# UNITED STATES PATENT AND TRADEMARK OFFICE

### Office Action Summary

10/524,957

PETROSENKO ET AL.

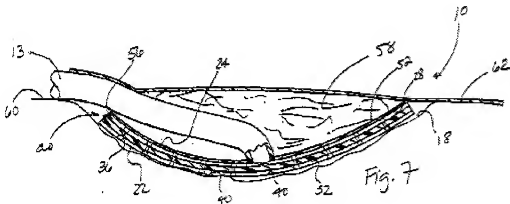
Regarding claim 1, Lockwood teaches a vacuum bandage system (10, 12) capable of being used with a wound (16) having a wound surface, the vacuum bandage system (10, 12) comprising:

a wound dressing member (52) made generally of a non-porous material having a plurality of holes and a port (70) in communication with the holes and capable of being coupled to a vacuum source (12), and a wound insert (20) capable of being placed within the wound (16) between the wound surface (18) and the wound dressing member (52), the insert (20) being made of a material which is not porous or foam-like, and

a cover (62) capable of placement over the wound dressing member (52) to seal about the wound (16) and create a sealed environment between the wound (16) and the cover (62) in which negative pressure can be established (§ 0031)(see figures 7 & 15).

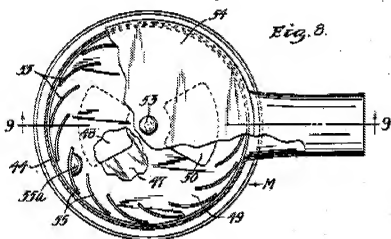
a cover (54) capable of placement over the wound dressing member (44) to seal about the wound and create a sealed environment (45) between the wound and the cover (54) in which negative pressure can be established (see fig. 9, *infra*)(col. 3, line 1).

Regarding claim 13, La Mere discloses that the insert body (M) is cylindrical or rod-shaped (see fig. 8, *infra*).
